Re: Docket No. 99-AFC-5

## PLANNING REPORT

SUBJECT: EAST OTAY MESA ENERGY PLANT: CONSIDERATION OF A RESOLUTION OF RECOMMENDATION TO THE CALIFORNIA ENERGY COMMISSION, EAST OTAY MESA SPECIFIC PLAN, OTAY SUBREGIONAL PLAN (District: 1)

RESOLUTION OF THE SAN DIEGO COUNTY )  
BOARD OF SUPERVISORS )  
RECOMMENDATION TO THE CALIFORNIA ENERGY COMMISSION )  
APPLICATION FOR CERTIFICATION )  
EAST OTAY MESA GENERATING PLANT, P00-000 )

# Site Plan

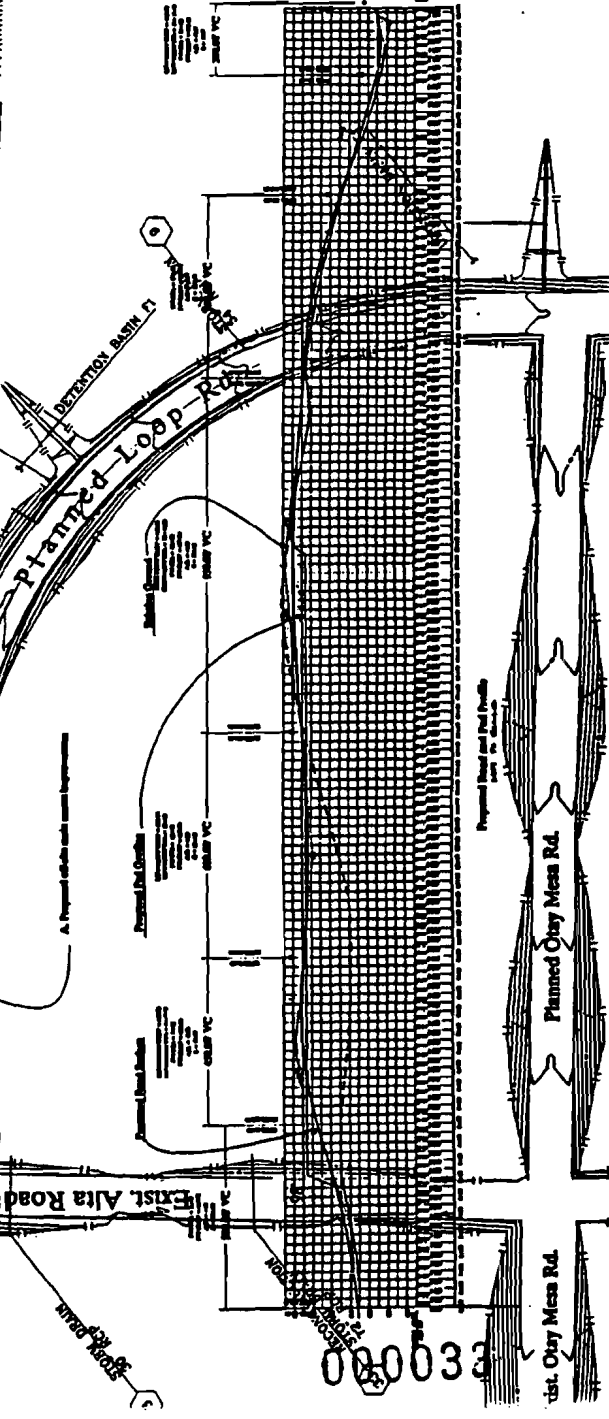
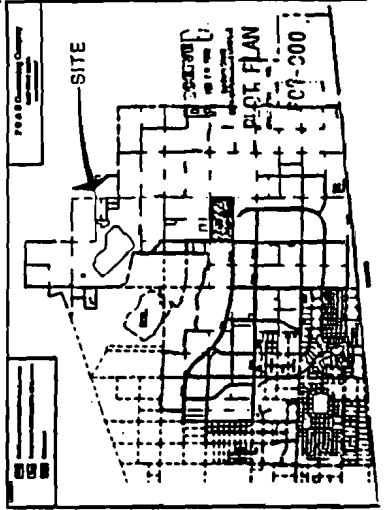
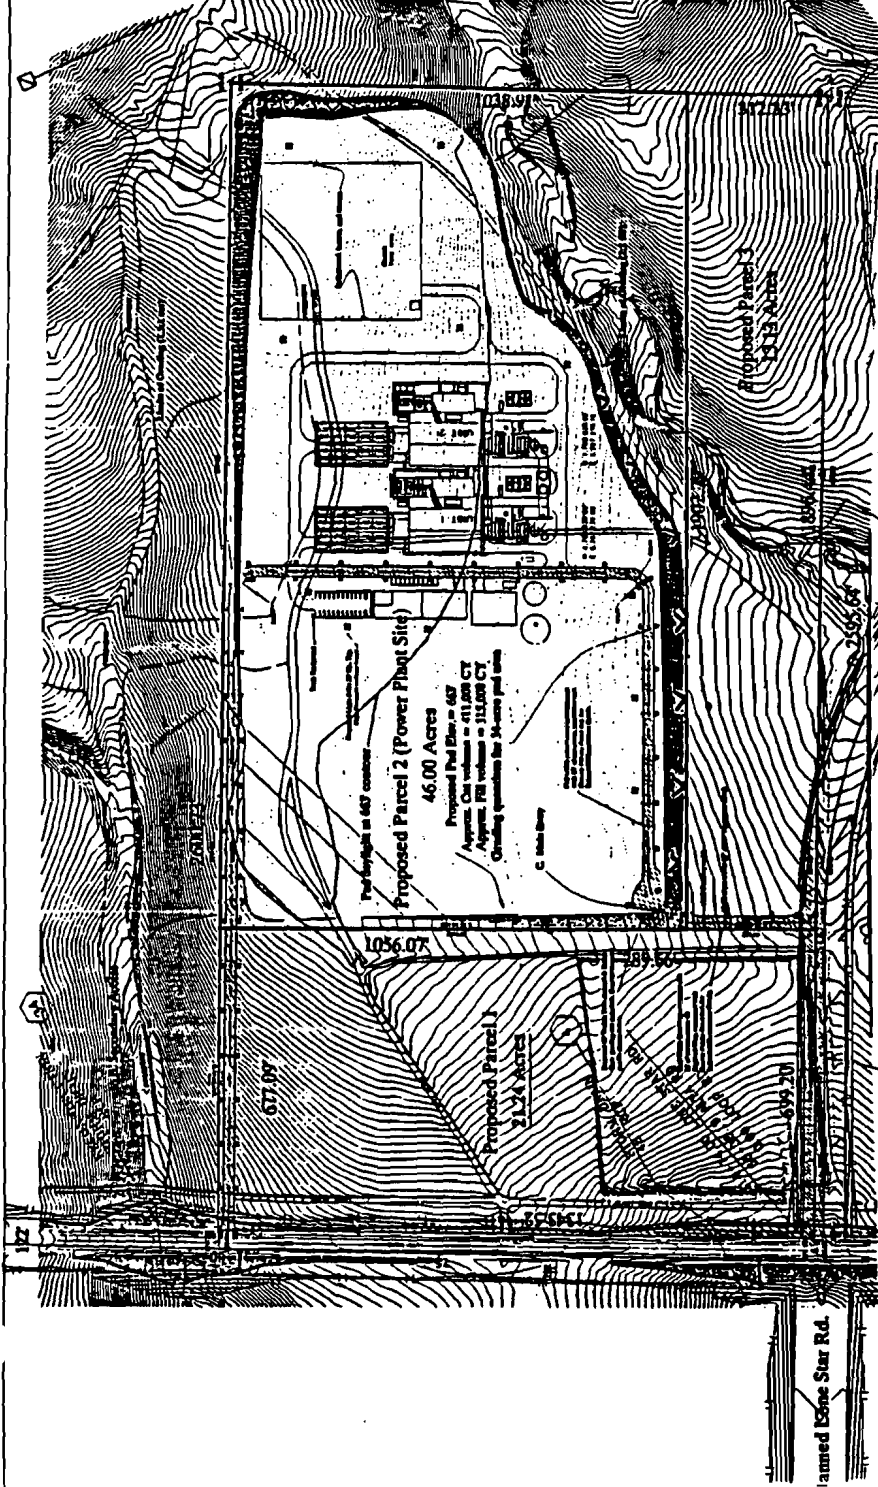
- b. No on-street parking shall be permitted and the proper signage shall be installed every 150 feet.
  - c. The cul-de-sac turn around shall be per the site plan dated February 28, 2000 with a 60 foot minimum radius.

3. The cul-de-sac turn around shall be per the site plan dated 2-28-2000 with a 60' minimum radius.
4. Any proposed access gates serving the facility shall be equipped with Fire Dept access key switch.(Knox Entry System).

# Power Plant Plot Plan

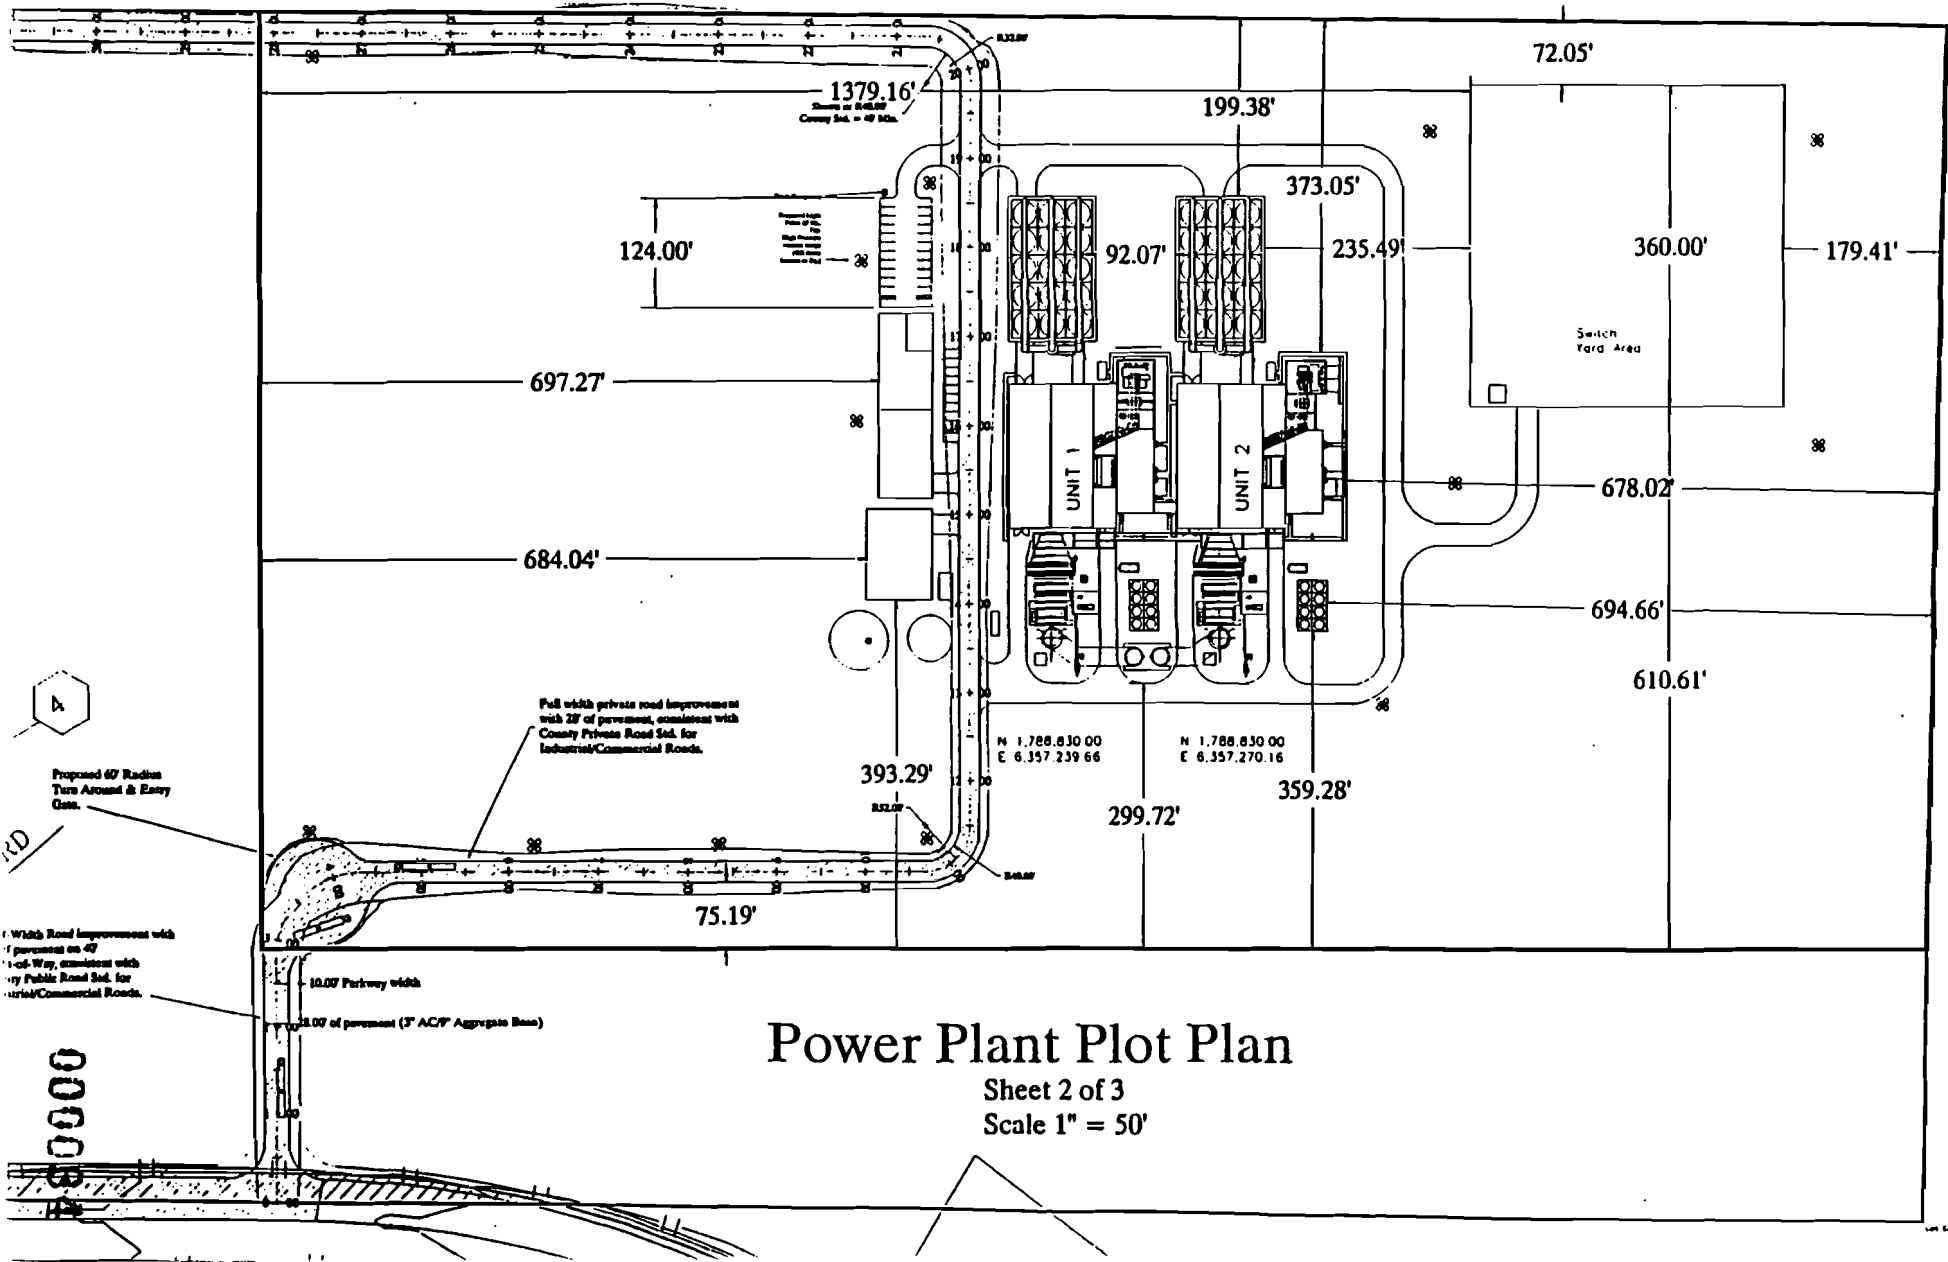
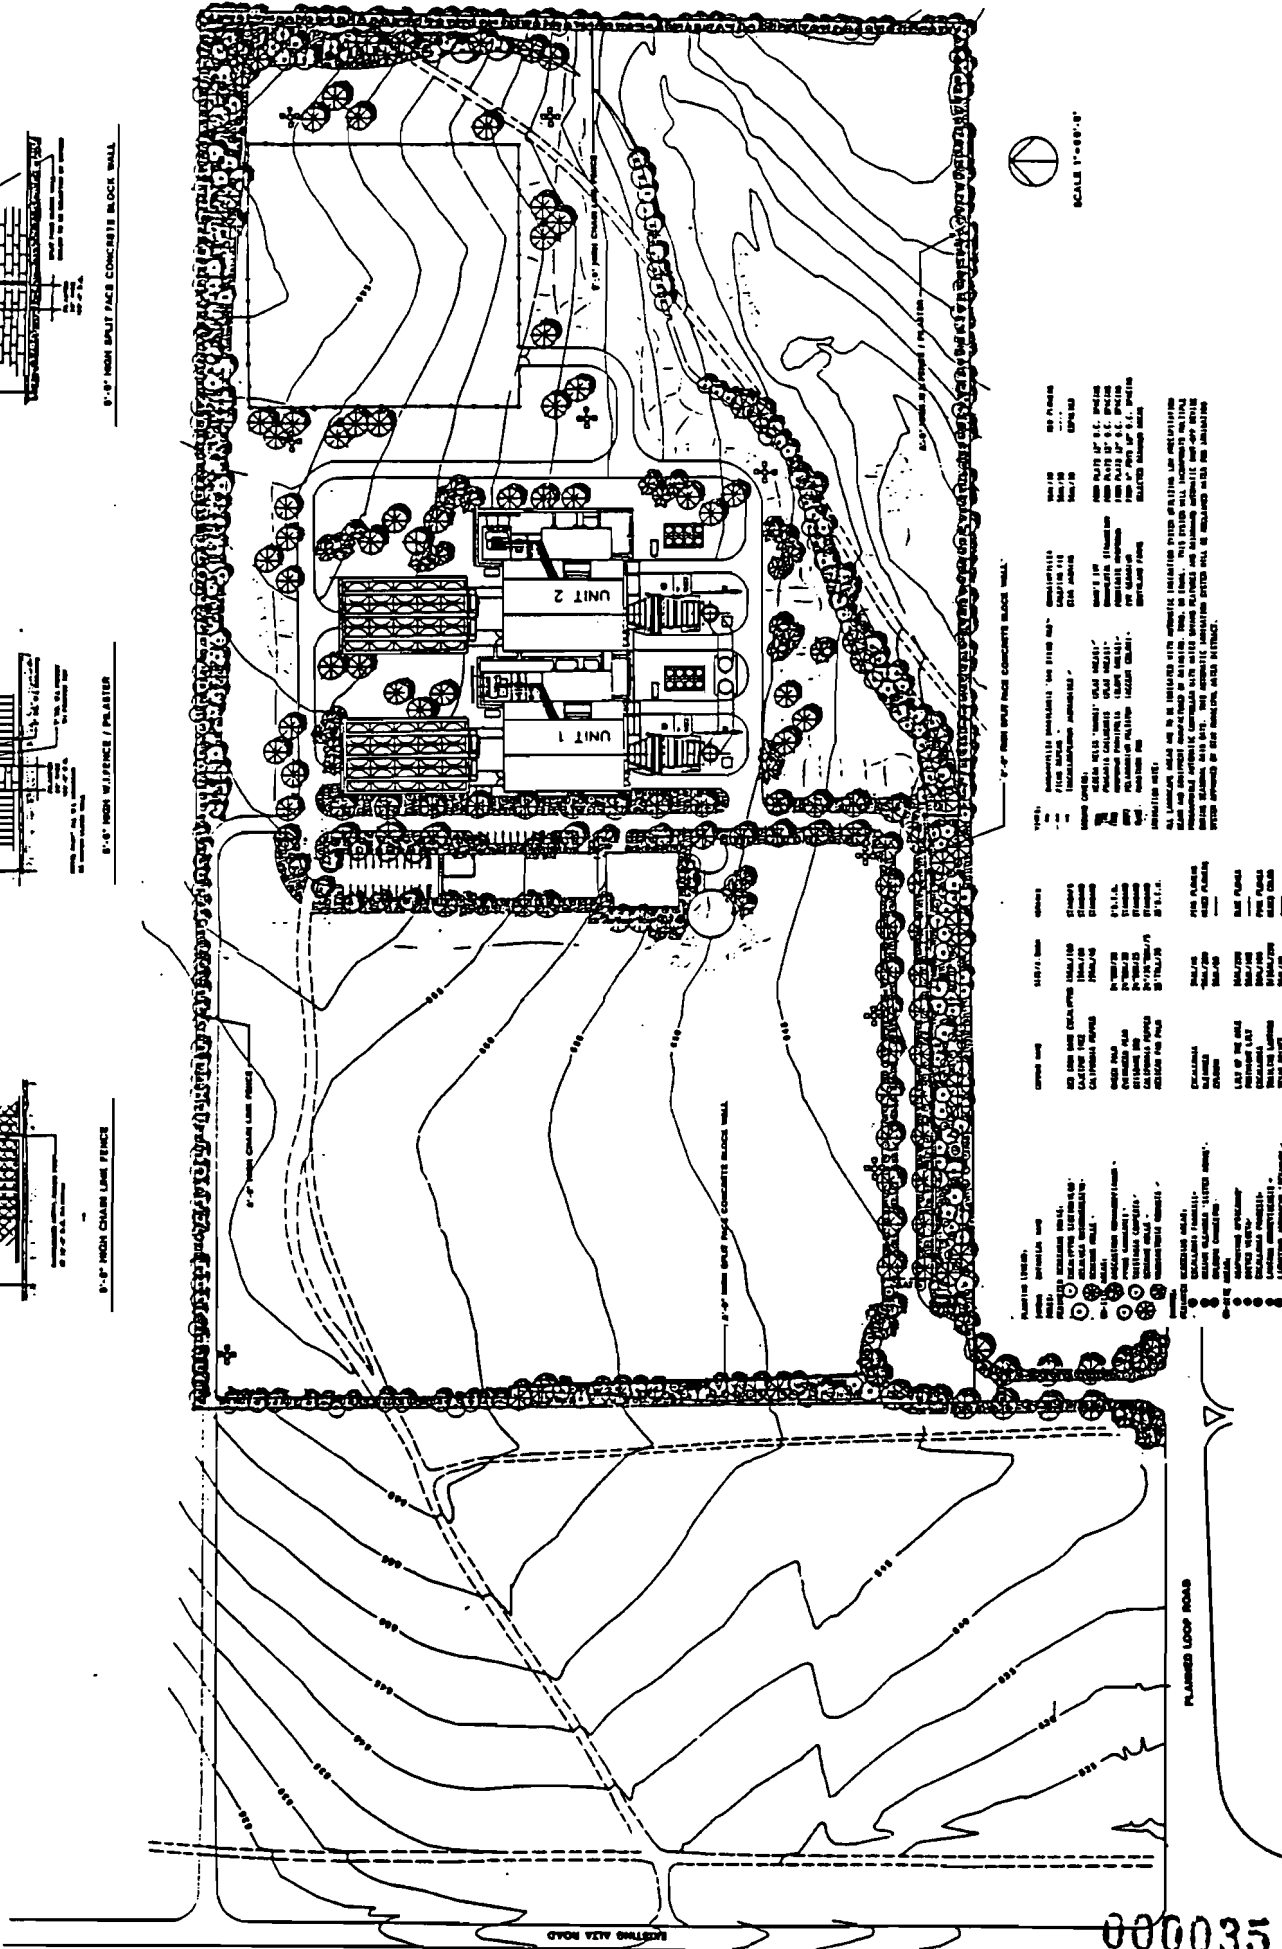
- A. Before the State grants the permit to construct and operate the subject power plant the applicant shall:
  1. Obtain approval from the Director of Planning and Land Use of a revised plot plan that shows the following revisions:
    - a. The project shall submit a revised grading plan that complies with the intent of the Specific Plan Site Planning and Design Guidelines for the requested change in slope ratio along the northern edge of the switchyard.
    - b. The distance between the driveway pavement and the northerly property line is required to be a minimum of 15 feet. The current conceptual landscape plan shows about 10 feet.
    - c. Provide a more suitable area for solid waste storage than the single trash receptacle at the northwesterly corner of the parking area. The best location for the solid waste storage area is adjacent to the administration building.

- d. **Make the following changes to the conceptual landscape plan so that the project is consistent with the East Otay Mesa Site Planning and Design Guidelines.**

- (1) **Reduce the number of Queen palms and Mexican fan palms because they tend to add to the visual incongruity of the project with its surrounding area. In addition, Mexican fan palms can be invasive. Replace the palms with trees that will provide visual screening.**

- (4) **Throughout the site there are trees shown to be randomly planted without any vegetative groundcover. If these areas are to be graded and existing vegetation is to be removed, then the conceptual landscape plan needs to show planting (groundcover, hydroseed, shrubs, trees, etc.) for these areas. If these areas are to be used for future expansion, then this must be noted and a temporary hydroseed or groundcover must be established to prevent erosion. If the existing vegetation is to remain, then this must be noted as well, with a condition that, if disturbed during construction, the areas will be revegetated with a hydroseed, groundcover, etc.**

- (5) **The plans need to call out a 3 inch layer of bark mulch in all planting areas.**
2. **Make the following changes to the text of the environmental assessments set forth in the AFC.**

**Fig. 3.5-1, Grading & Drainage Plan**

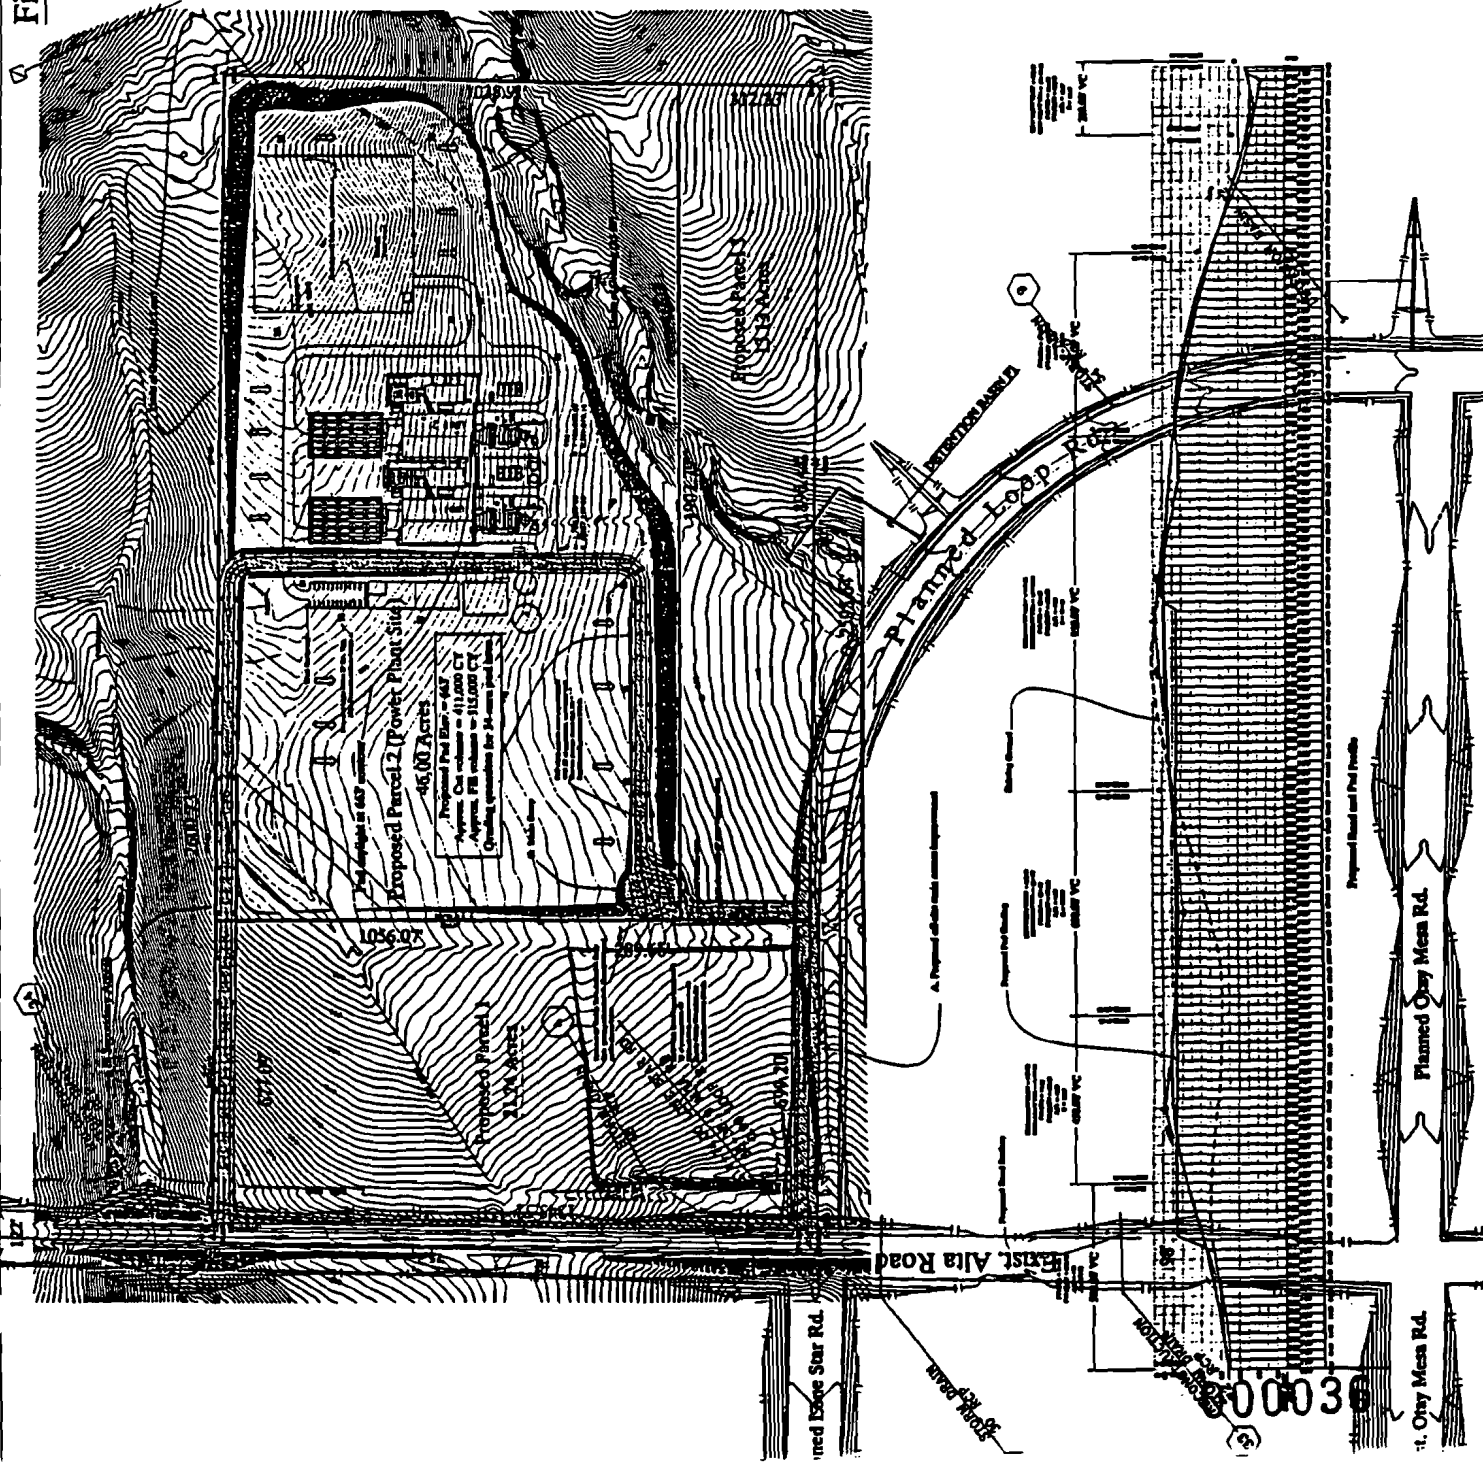
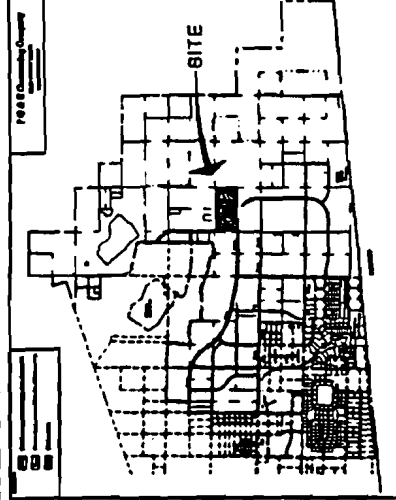
1. Make the grading more consistent with the Site Planning and Design Guidelines which require a maximum slope height of 15 feet and a maximum slope ratio of 3:1.
2. Change the landscape concept plan as follows:
  - a. Reduce the number of palms because they are incongruous and invasive.
  - b. Paint the building so that is blends with the natural backdrop.
  - c. Move fencing and landscaping out of the natural drainage and place at the top of the slope above the drainage.
  - d. Provide more trees for screening and groundcover for erosion control.

Within the East Otay Mesa Specific Plan the land planned for industrial and commercial development is generally rolling terrain having slopes less than 15 percent. The Guidelines indicate that the limits and constraints of grading and the resultant cut and fill banks shall incorporate the requirements illustrated in "Figure 2". Figure 2 indicates a maximum vertical slope height of 15 feet with a slope ratio of 3:1 maximum.
